HISTORIC SITE PRESERVATION BOARD STAFF REPORT

DATE: May 13, 2014

SUBJECT: A CERTIFICATE OF APPROVAL APPLICATION BY PACIFICA L 39, LLC, FOR APPROVAL OF A PROPOSED ENTRY PORTICO TRELLIS STRUCTURE, SIGN, AND SCREEN WALLS AT THE MAIN ENTRANCE OF THE TRIADA HOTEL & SPA (FORMERLY THE SPANISH INN) A CONTRIBUTING STRUCTURE SUBJECT TO CLASS 1 REGULATIONS IN THE LAS PALMAS BUSINESS HISTORIC DISTRICT (HD-1) LOCATED AT 640 NORTH INDIAN CANYON DRIVE. (CASE 5.1049 MAA, HSPB 49) (KL)

1 SITE / KEY PLAN - LEVEL 1
1/16" = 1'-0"

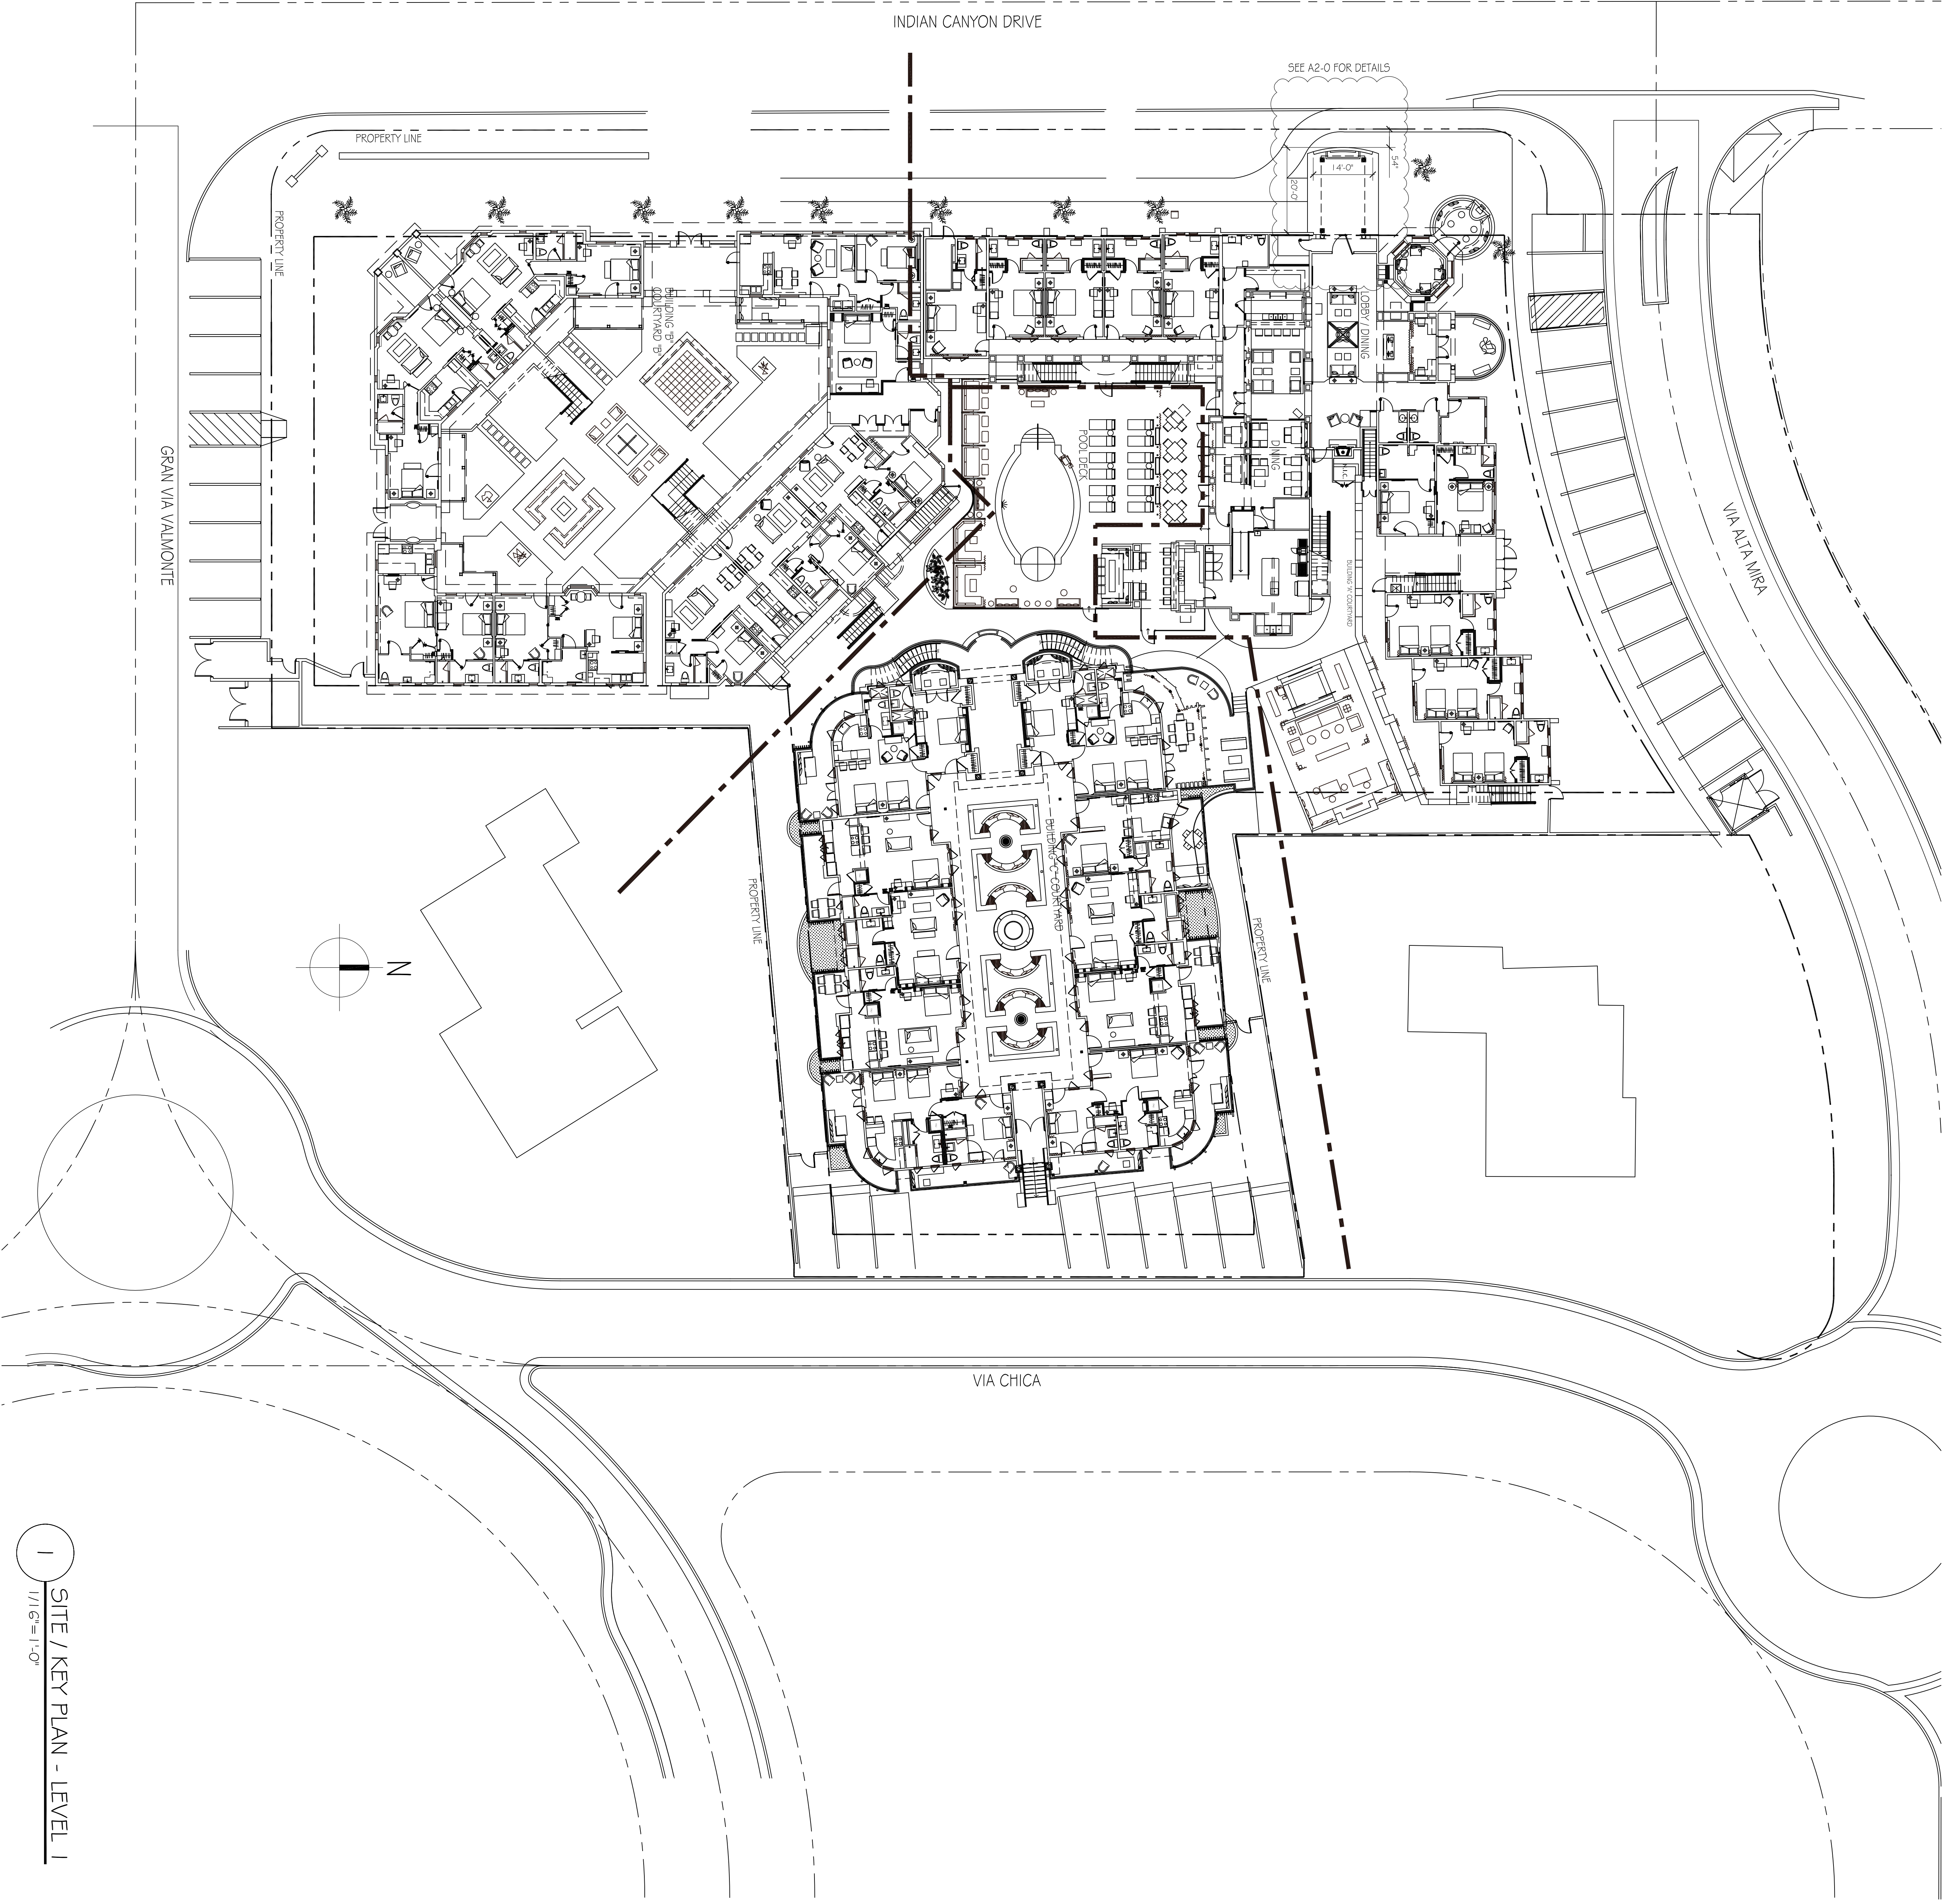
Guideline:	Conforms	Staff Evaluation:
1	Does the proposed development provide a desirable environment for its occupants?	Partially	<p>1. Portico Trellis: The proposed entry portico provides a prominent architectural element that draws attention to the main entry of the Triada Hotel. As a trellis, it provides no effective shade or protection from sun or rain.</p> <p>2. Wall at Portico: The wall at the portico trellis provides a seated waiting area at the valet station; the zoning code requires it to be reduced in height from 6 feet to 4.5 feet.</p> <p>3. Blind Arcade at arched entry: The proposed wall at the arched entry along the Indian Canyon Drive frontage provides security and privacy for hotel guests in the courtyard.</p> <p>4. The proposed second main sign aids in directing visitors to the main entry.</p>
2	Is the proposed development compatible with the character of adjacent and surrounding developments?	Partially	<p>1. The portico is proposed with white precast Doric columns that support a painted dark brown steel trellis structure. Doric style columns were added to the main building with the 2005 addition of the tower element. The wide flat arch of the trellis, however has no precedent in architecture of the existing hotel building. The existing entry door behind the proposed trellis is set in a Serliana or Palladian-type arched opening. The proposed trellis is also not consistent with this entry feature.</p> <p>2. Wall at portico: The proposed ledgestone wall is similar to existing walls enclosing the air conditioning condensing units, however they are shorter in height, less obtrusive and screened behind landscaping. Staff has conditioned the wall to conform with the maximum allowable height for this location.</p> <p>3. Blind Arcade: The proposed wall at the archway is compatible with the character of the existing hotel. A condition of approval is included to reinstall the ornamental iron to further enhance the appearance of this privacy wall.</p> <p>4. The proposed second main sign is compatible with the character of the hotel.</p>

3	Is the proposed development of good composition, materials, textures, and colors?	Partially	<p>1. Portico Trellis. The materials textures and colors proposed are compatible with the existing historic hotel, however the composition of the wide, flat trellis arch does not integrate well with the architecture of the existing hotel, nor does it provide shelter from intense summer sun and rain.</p> <p>2. Wall at portico: The materials are appropriate for this wall, however staff has conditioned it to be 4.5 feet in conformance with the Zoning Code.</p> <p>3. Blind Arcade: The proposed wall is of good materials and is proposed to match the color and texture/finish of the adjacent stucco of the hotel. The proposed fan-arch window at the top of the blind arcade wall does not relate well with the existing Spanish Colonial Revival architecture of the hotel.</p> <p>4. The proposed second main sign is of good material, composition and color.</p>

5	Harmonious relationship with existing and proposed adjoining developments and in the context of the immediate neighborhood/community, avoiding both excessive variety and monotonous repetition, but allowing similarity of style, if warranted	Partially	<p>1. Portico trellis and wall: As noted above, the proposed portico trellis and wall generally relate to the existing building and help in visually demarking the hotel entrance, however architecturally, its detailing is less than successful in its integration with the architecture of the existing hotel.</p> <p>2. The blind arcade is harmonious with the existing architecture of the hotel.</p> <p>3. The proposed second main sign helps direct guests to the main lobby and check-in. Its style is consistent and complementary with the previously approved main sign at the southwest corner of the site.</p>
6	Maximum height, area, setbacks and overall mass, as well as parts of any structure (buildings, walls, screens, towers or signs) and effective concealment of all mechanical equipment	Partially	<p>1. Entry Portico: Pursuant to PSZC 93.01.00 porte-cocheres and similar structures are permitted in the front yard setback of a multi-family residential zone. Pursuant to PSZC 93.02.00 walls in front yards of multi-family residential zones may not exceed 4.5 feet unless located at least 15 feet away from the front property line. The masonry wall at the entry portico trellis is proposed at 6 feet, but staff has conditioned it to not exceed 4.5 feet which is the maximum allowed in this location.</p> <p>2. The blind arcade provides effective privacy and security for the hotel guests.</p>

The project proposes a new entry portico trellis, masonry wall, second main sign, and closure of an arched entry porch into a blind arched arcade. As noted above, the proposed portico trellis does not attach to the existing building. The portico trellis structure proposes Doric columns consistent with those on the existing building entry. The wide, low arch of the trellis, however, does not seem to relate to the full half-round arches found throughout the site. The masonry wall is proposed in a ledgerstone veneer that is consistent with the mechanical equipment enclosures also located along this street frontage. The proposed wall at the arched entry porch will provide privacy and security for hotel guests while still retaining the archways. Staff has included a recommended condition of approval to reinstall the ornamental ironwork in front of the blind arcade to add visual richness to that element of the building.

1. The masonry wall at the west side of the portico structure shall not exceed 4.5 feet in height.
2. An application for an Encroachment Permit must be made between the Owner and the City of Palm Springs pursuant to PSMC Chapter 14.16.
3. Integrate a solid cover or roof element on the trellis to provide shade and protection from rain.
4. Reinstall the ornamental iron in front of the proposed blind arcade for decorative purposes.
5. Delete the proposed fan-lite windows in the blind arcade as not in keeping with the architecture of the historic hotel.
6. Integrate landscape at the proposed portico consistent in species, size, etc. to that of the existing landscape at the Triada Hotel.

BUILDING LOGO

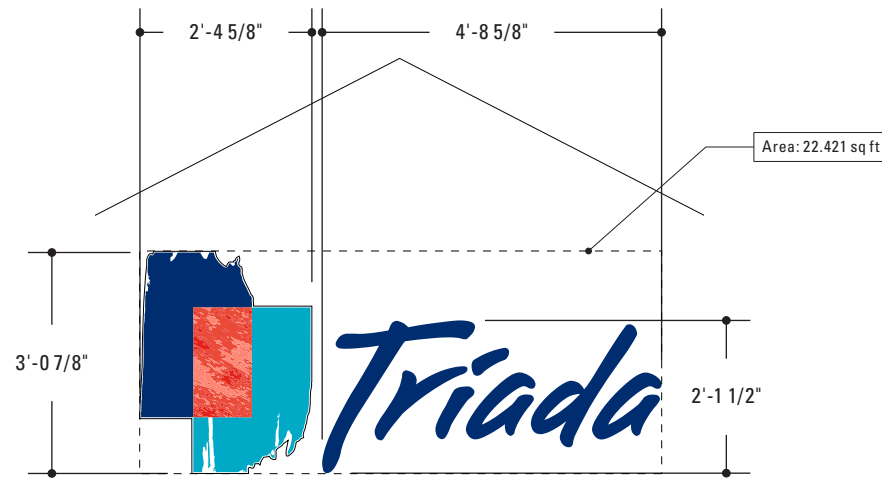
The proposed second main sign is complementary and consistent with the main sign at the southwest corner of the site. It is located more than 170 feet from the other main sign. It is located at the valet drop off lane (access drive) and adjacent to the corner of North Indian Canyon Drive and Via Alta Mira. The proposed sign conforms to the requirements set forth above.
